Hi-Fi Products
Service Bulletin

Model: MHC-1600, HCD-H1600

No. 255R1

Subject: Wrong Display/No System Power

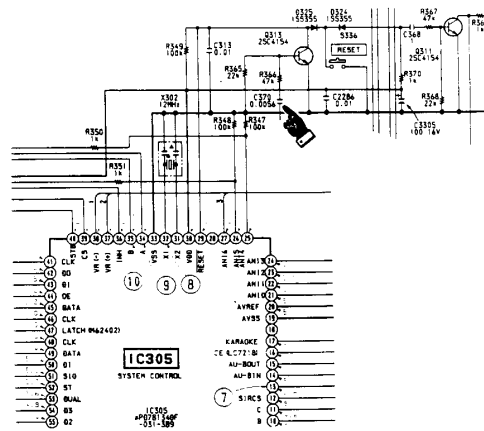
Symptom:
(13)

1. Wrong display (ex. "KARAOKE" will appear in the display or receiving frequency on the tuner will not be indicated properly).
2. System power will not be turned on.

Solution: Change the value of C370 on the panel board from 0.056 F to 0.1 F.

REF.	DESCRIPTION		PART NUMBER
	FORMER	NEW	
C-370	0.056 F	0.1 F	1-163-038-00
